APPEAL SUMMARY

Appeal ID: 23490

Project Address: 9551 SW 62nd Dr

LUR or Permit Application No.: 18-251393-RS

JOHNSTONE BASEMENT BATHROOM RENOVATION DETAILS:

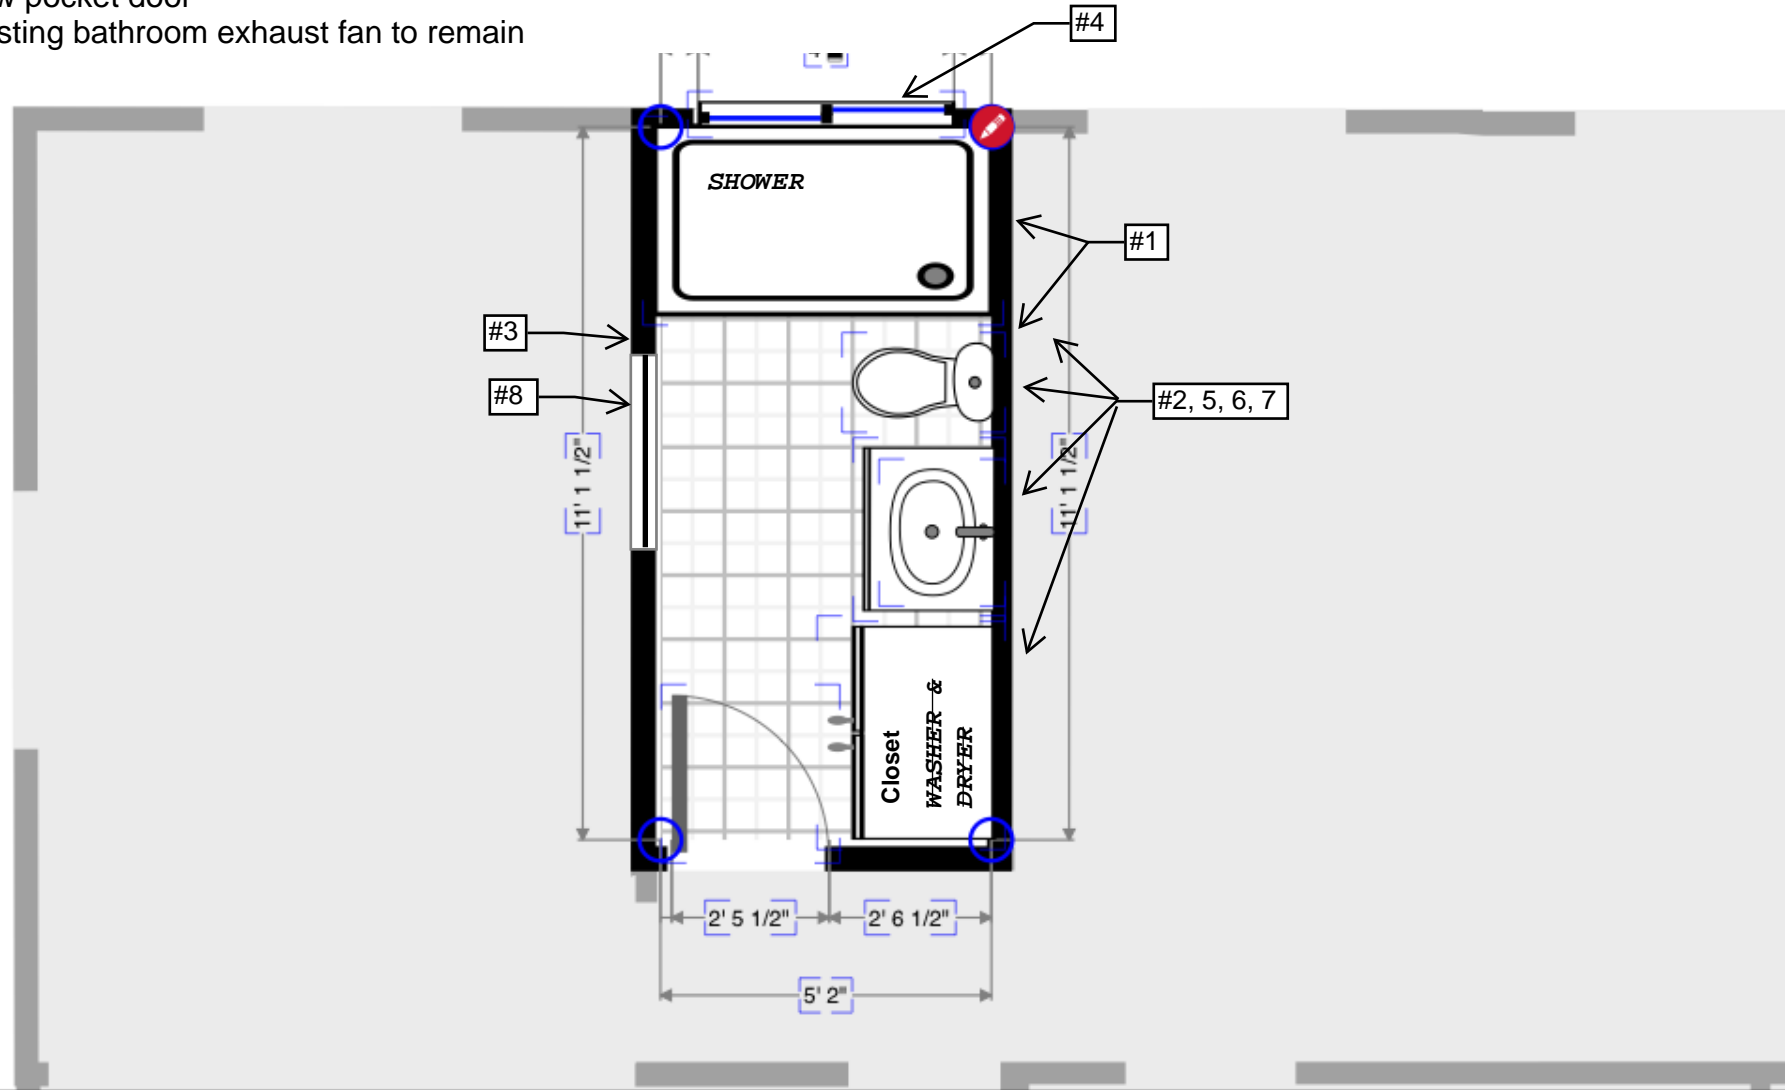
I request that the existing door opening be replaced with a 20 minute door not one hour.

In summary of the information provided above, I wish to contest that the door opening (that we agree can remain at the bottom of the stairs) should be replaced with a 20-minute fire rated door and not a 1-hour door for the following reasons:

#1 Existing solid core door to storage room

**#2 Existing solid core door to enter ADU
at the bottom of the stairs**

Use of solid core 20 minute door between main unit and ADU: Denied. Proposal does not provide equivalent Life Safety protection.
